**ALBERTA TRANSPORTATION SPRINGBANK OFF-STREAM RESERVOIR PROJECT  
RESPONSE TO NRCB AND AEP SUPPLEMENTAL INFORMATION REQUEST 1, JULY 28, 2018**

Errata  
May 2019

## 10 ERRATA

Figure IR538-2 shows the correct and different valid four distances of various Project features from the Tsuut'ina Nation Reserve. Each of these ways of measuring distances is used in the EIA and not only is the PDA referenced. The following is a description of these distances:

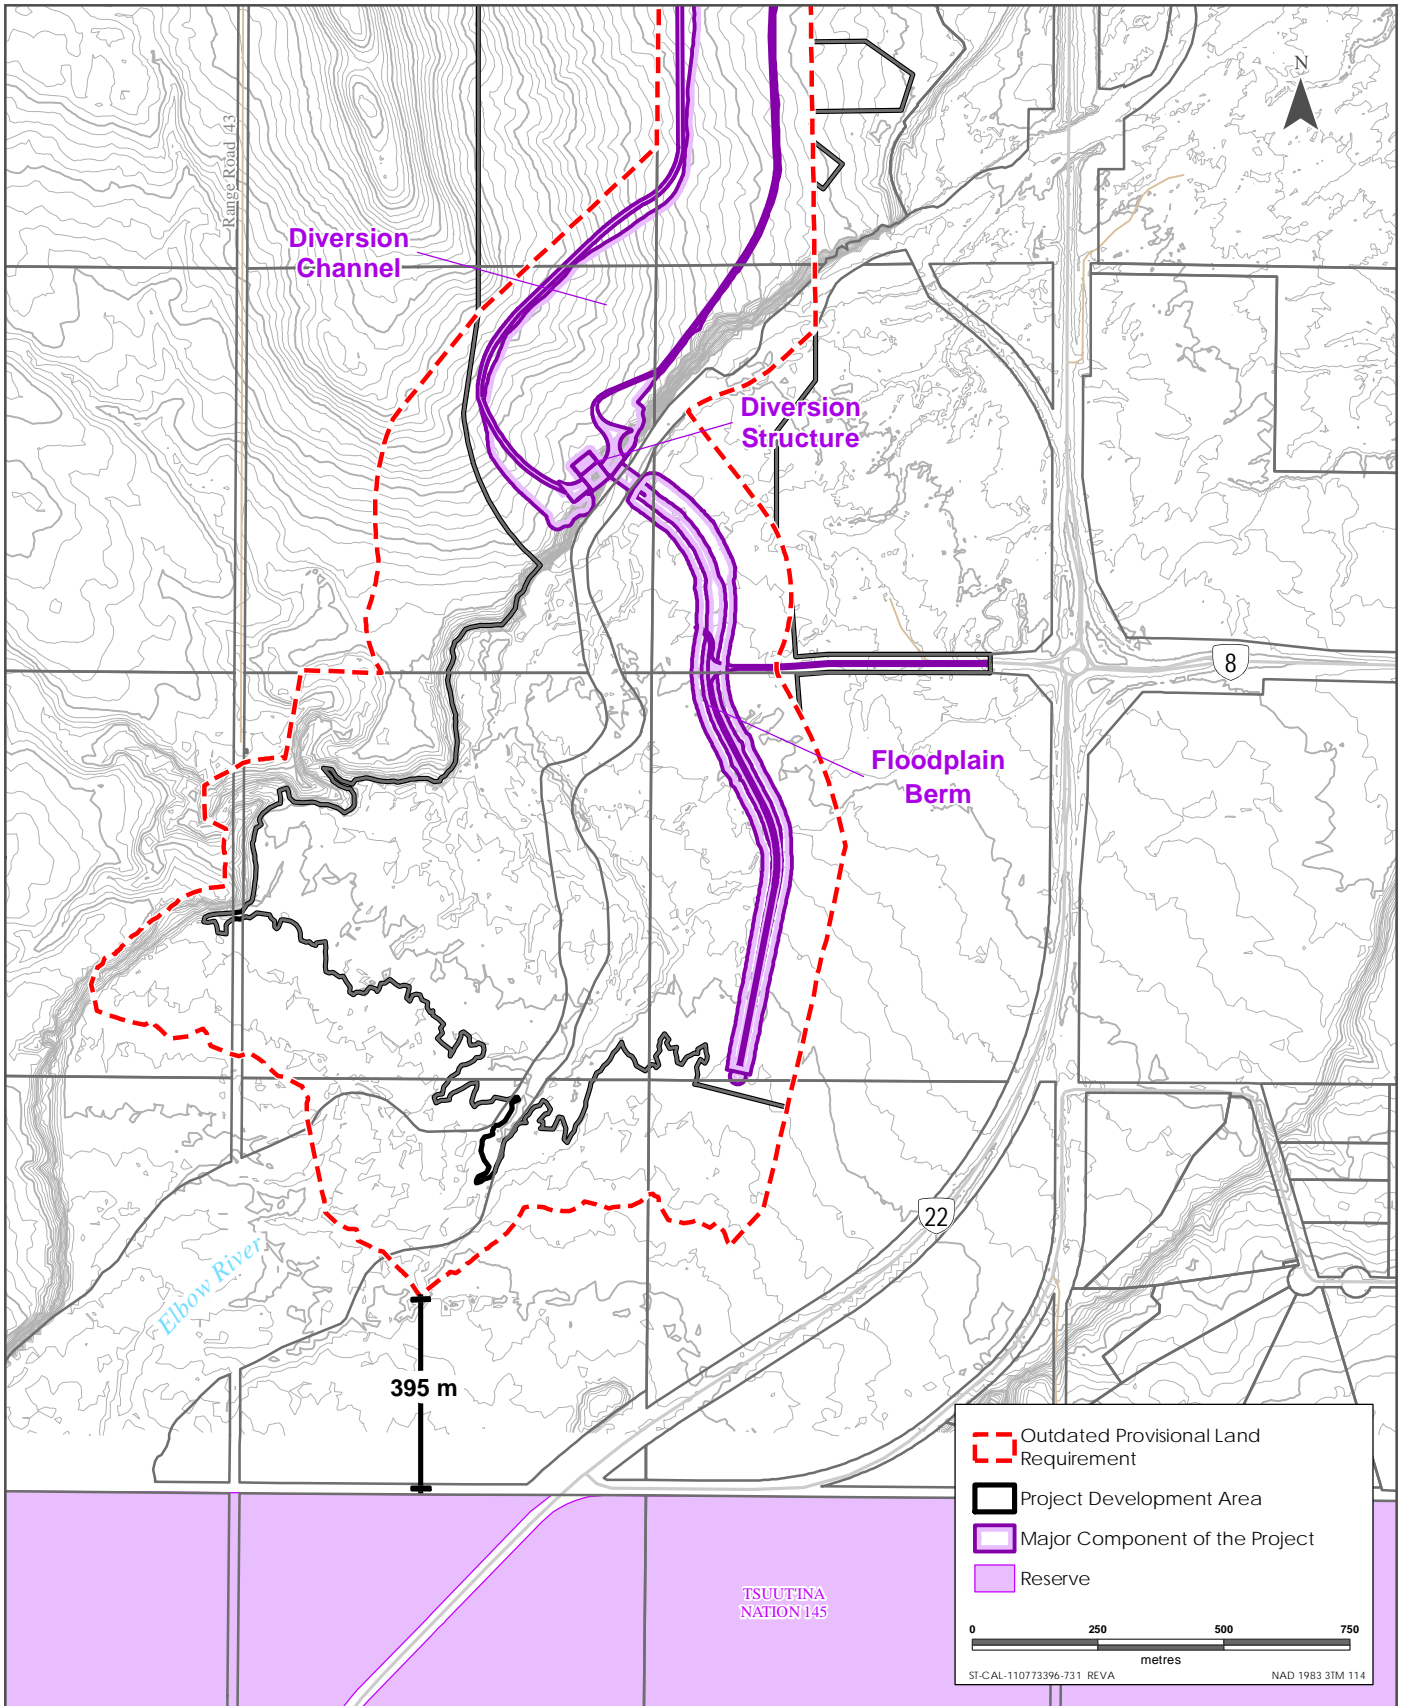
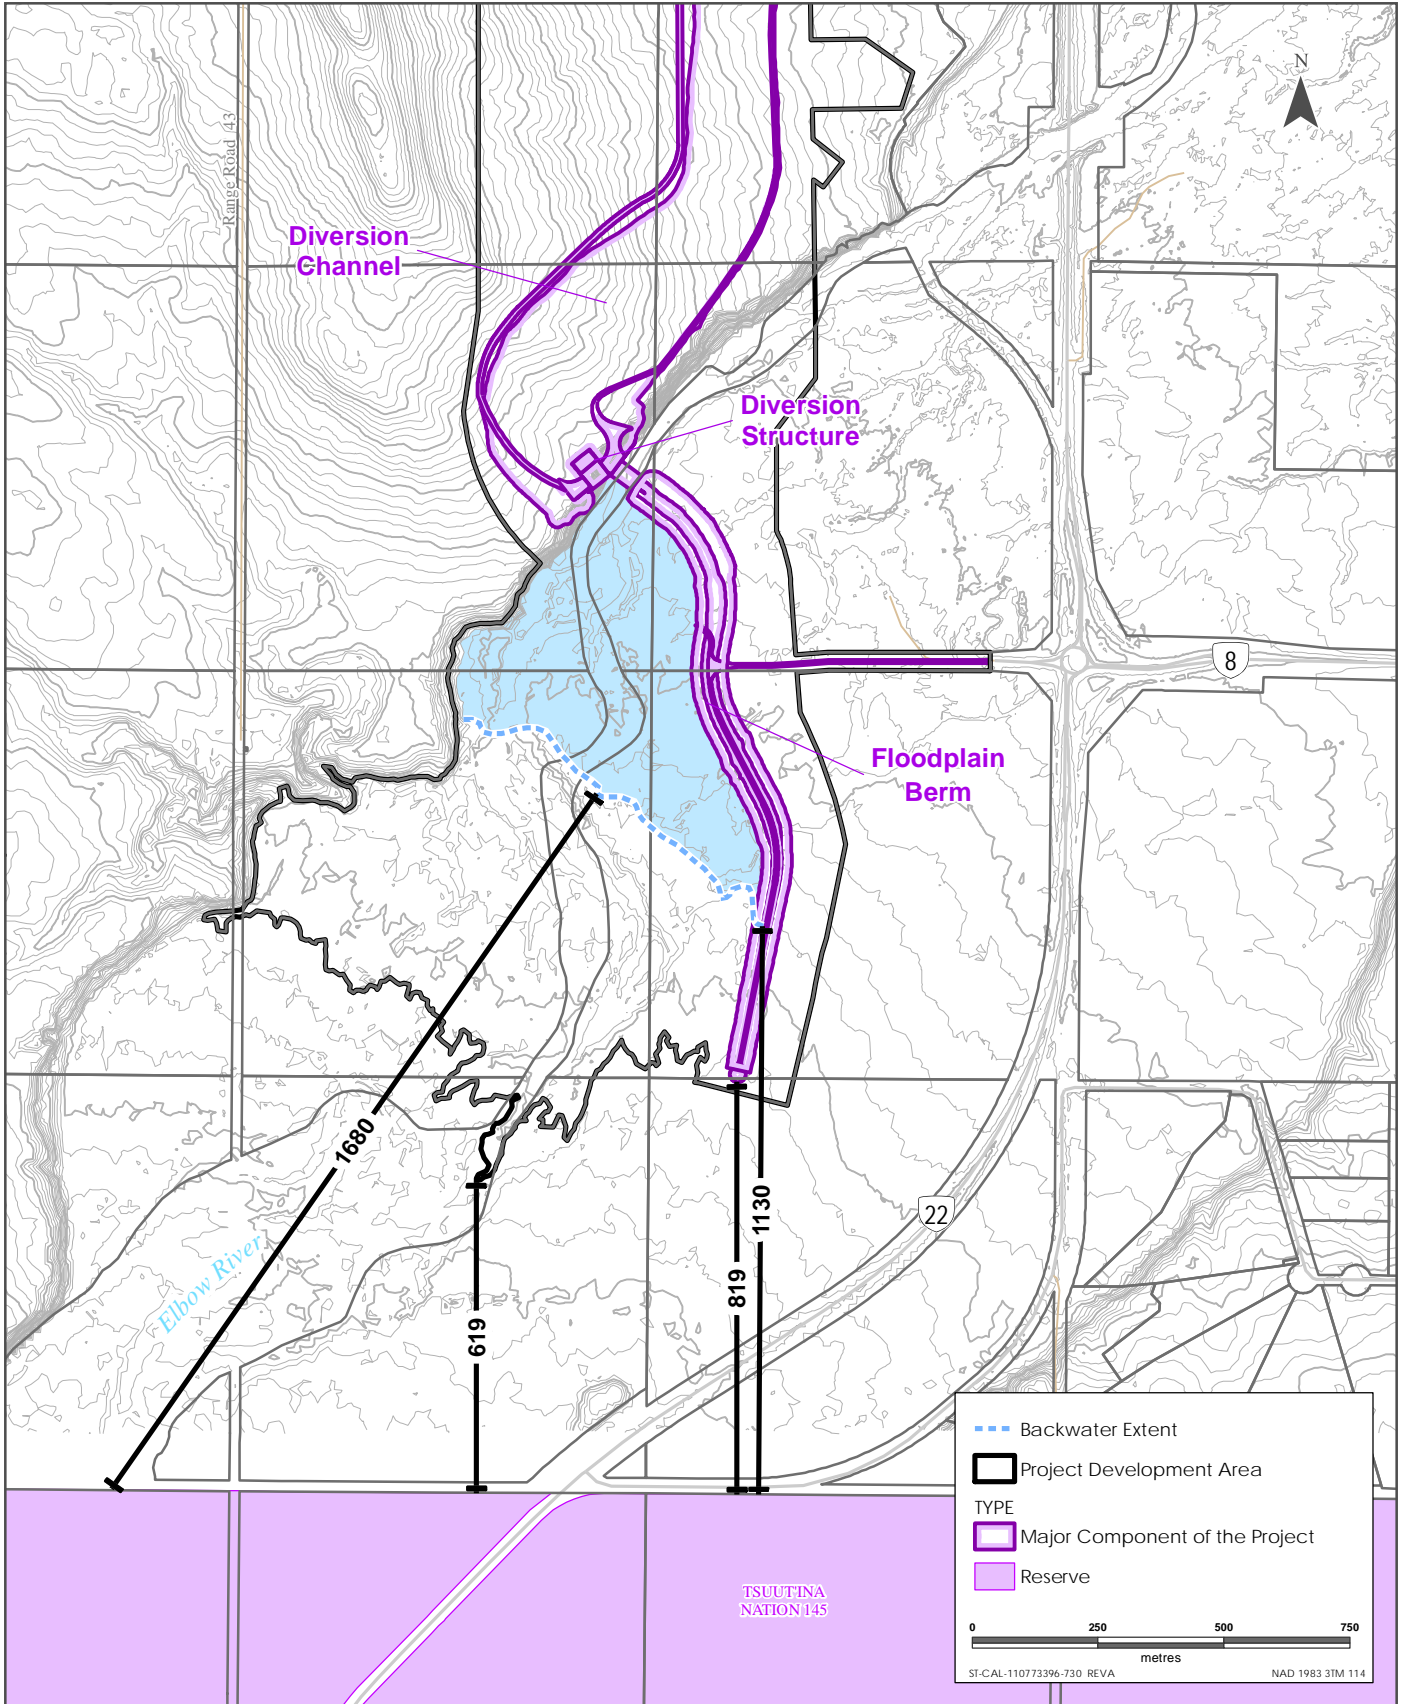
Section 1.3.1 states that Tsuut'ina Nation is located 619 m south of the southernmost part of the PDA. Whereas Table 7-3, Page 7.12 references a distance of 395 m in the first column but then states in the second column that the closest point of the Project to the Tsuut'ina Reserve is 930 m.

- a. Clarify the distance between the PDA and the Tsuut'ina Nation. Update the sections as required so that the correct distance is used.

- a. The 395 m distance is cited in the Project Description (Alberta Transportation 2016). Figure IR538-1 shows the outdated boundary of the Project (Provisional Land Requirement) that was used to calculate that distance. The initial Project design in March 2015 identified possible additional lands that might be needed for Project operation. Later revisions indicated that such lands were not necessary.

- 1,680 m is the distance along the Elbow River from the border of the Tsuut'ina Nation Reserve lands to the extent of the backwater in the event of a diversion of the design flood.
- 1,130 m is distance to backwater extent at the design flood; this is the same scenario as the 1,680 m distance, but it is not a possible flow path for water.
- 819 m is the distance from the closest Project structure (the terminus of the floodplain berm) to the border of the Tsuut'ina Nation Reserve lands.
- 619 m is the distance of Tsuut'ina Nation Reserve lands from the PDA

Location of Hound's Tongue

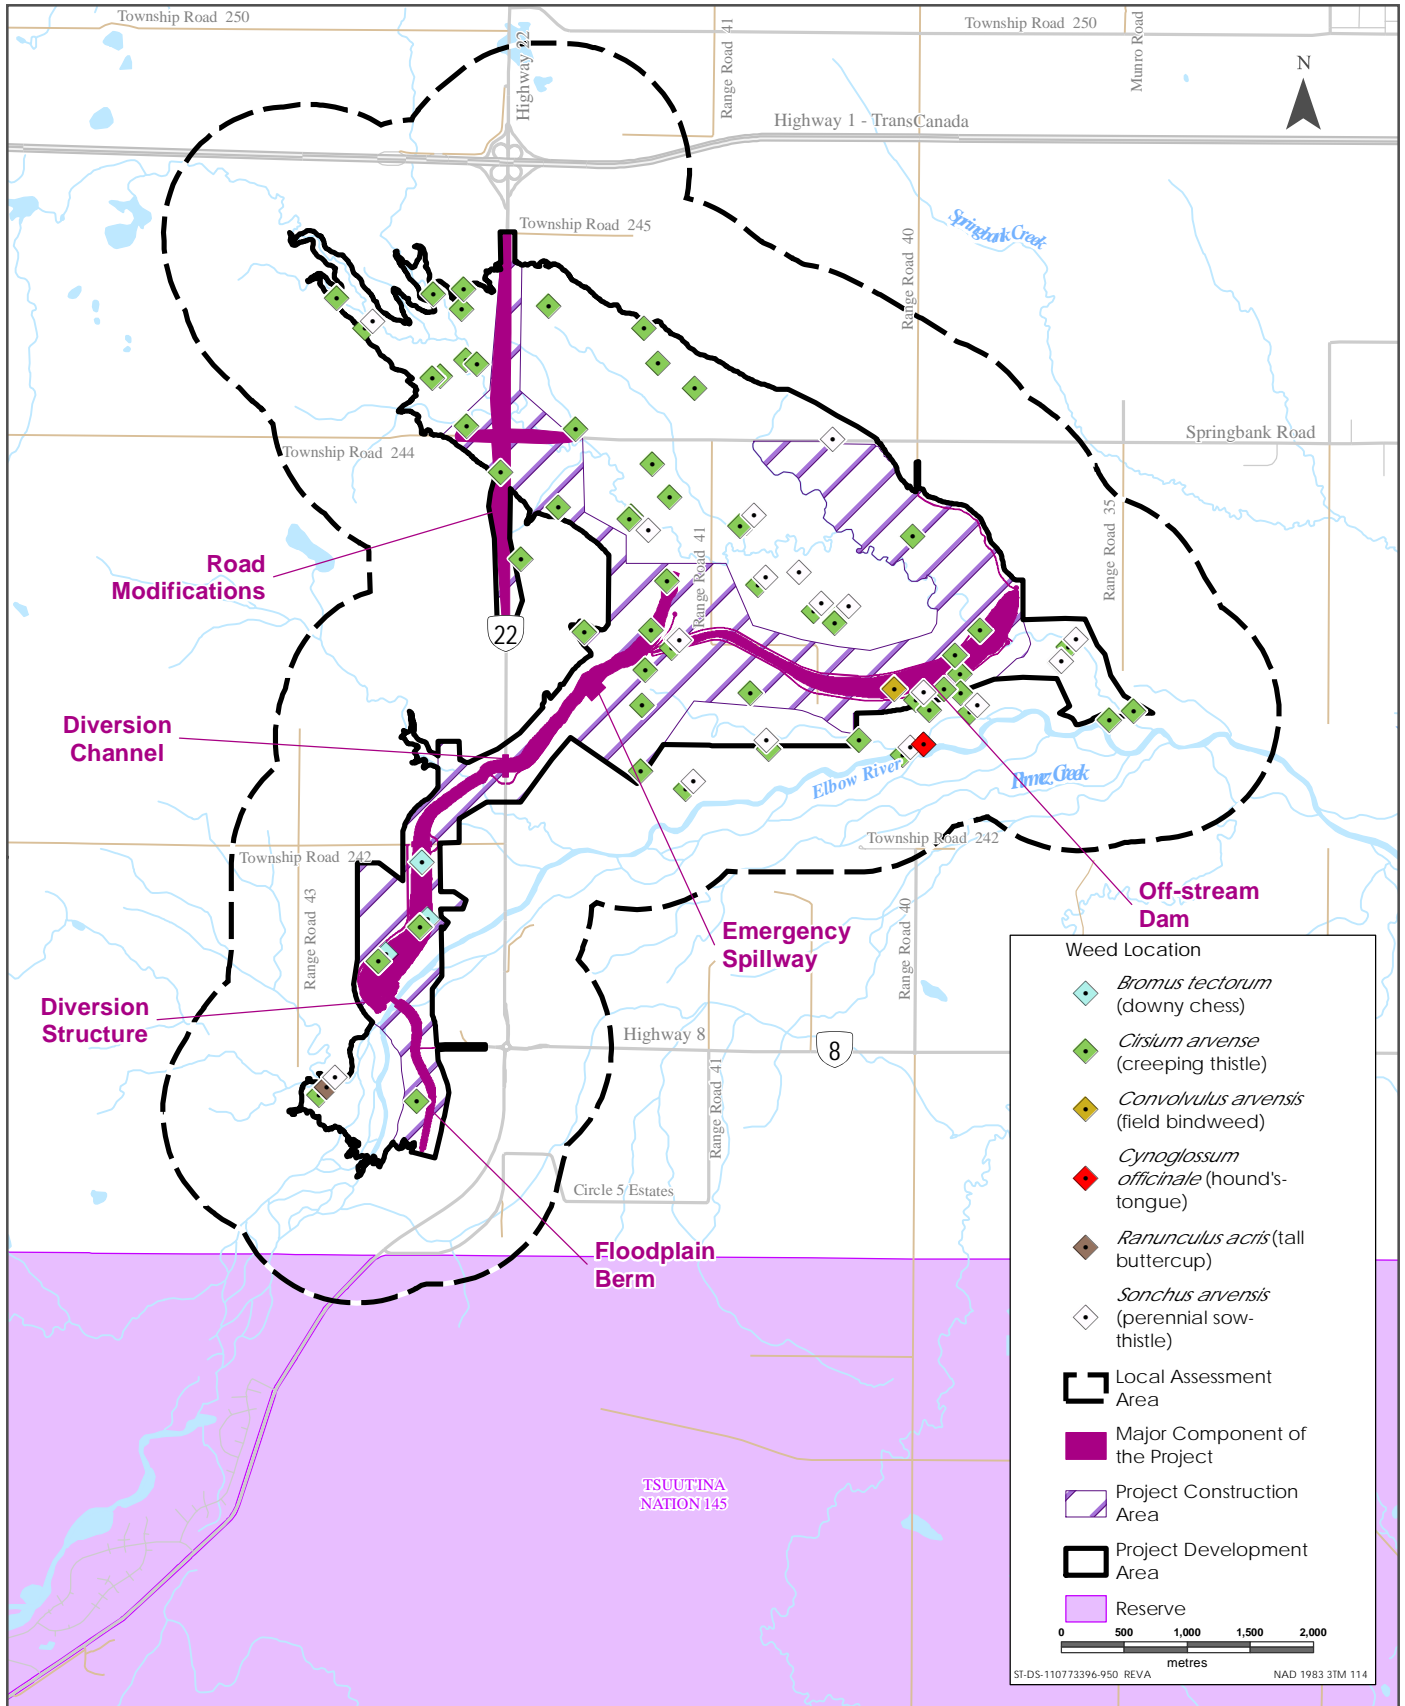
Reference is made to the presence of hound's tongue, but no point for this species can be located on Figure 10-5.

- a. Point out the presence of Hounds Tongue on Figure 10-5.

- a. Figure 10-5 in Volume 3A, Section 10 does not show the presence of hound's tongue. See Figure IR547-1 for the location of hounds tongue.

Figure IR553-1 Suspended Sediment Concentration in the Low-level Outlet and its Confluence with Elbow River for the 1:100 Year Flood (revision to Volume 3B, Section 6, Figure 6-20)

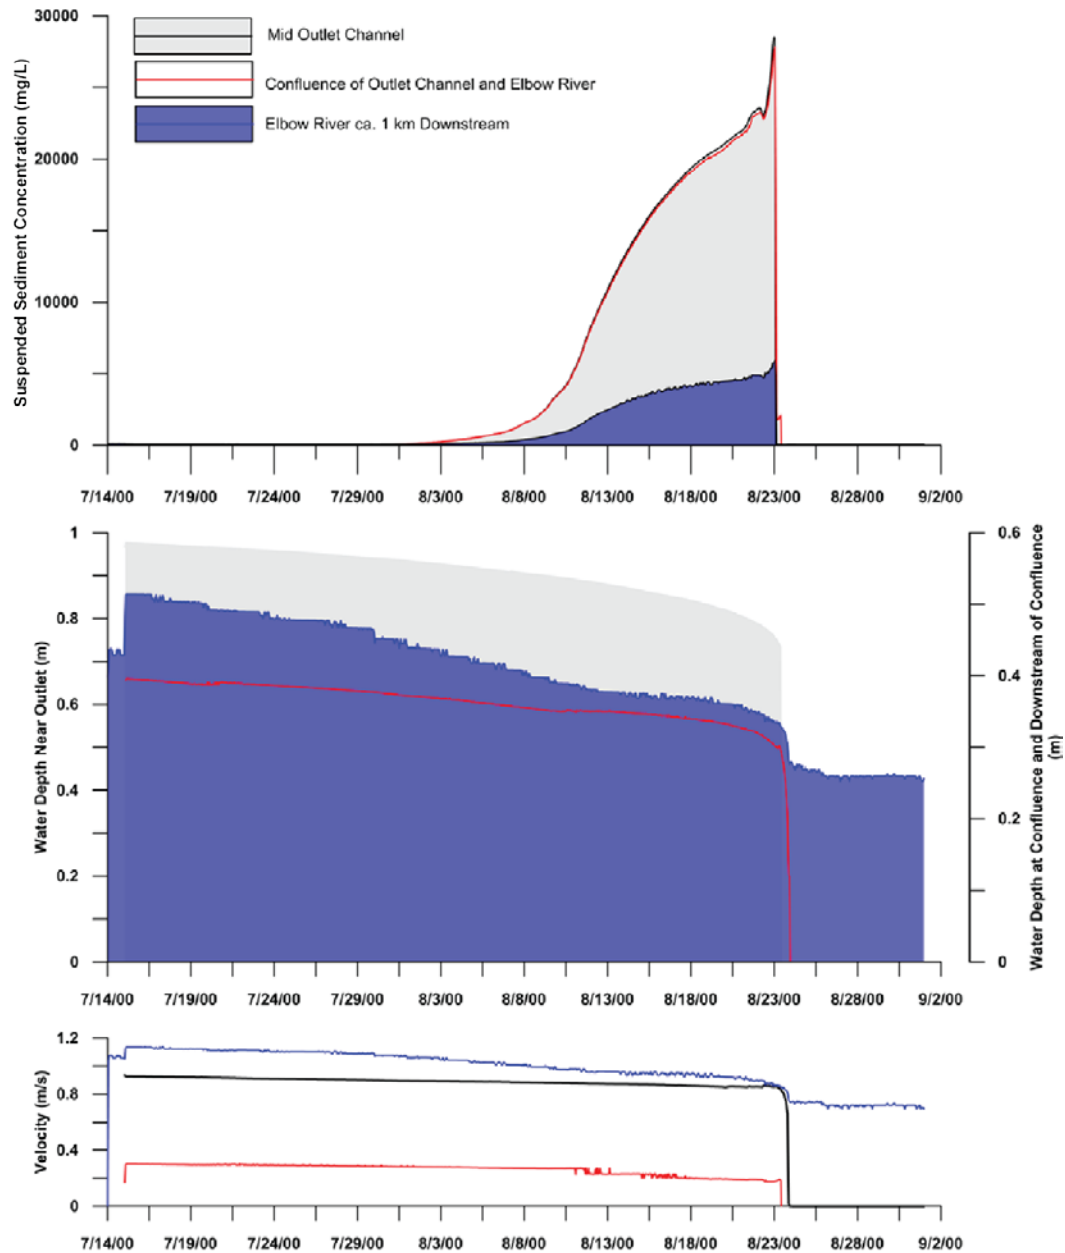
- a. Provide the y-axis label for the top plot of Figure 6-20 as it is missing.

- a. The y-axis should be labelled as follows: "Suspended Sediment Concentration (mg/L).

Figure IR553-1 is a revised version of Figure 6-20.

Figure IR577-1 Suspended Sediment Concentration, Discharge Rating Curves  
 (additional information added to Volume 4, Appendix J, Figure 3-12)

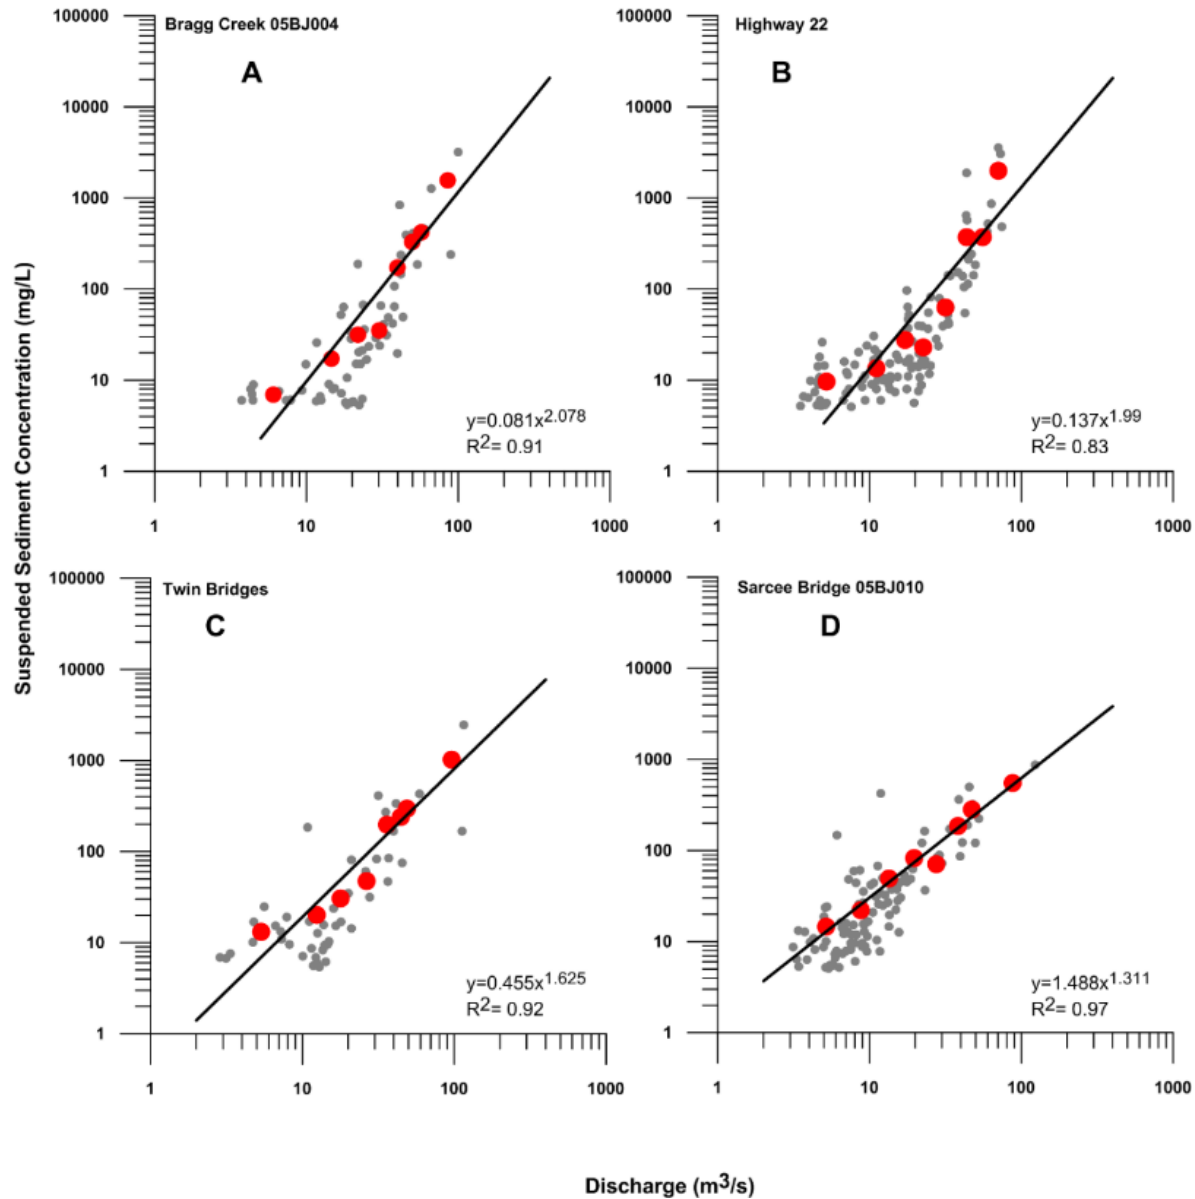
- a. Provide legends for the grey and red circles used in the plots.

- a. See Figure IR577-1 for the explanation of grey and red circles in Figure 3-12 and Figure IR577-2 for explanation of the same in Figure 3-14.

Red circle – Average suspended sediment concentration for associated average discharge rate (flow in Elbow River).
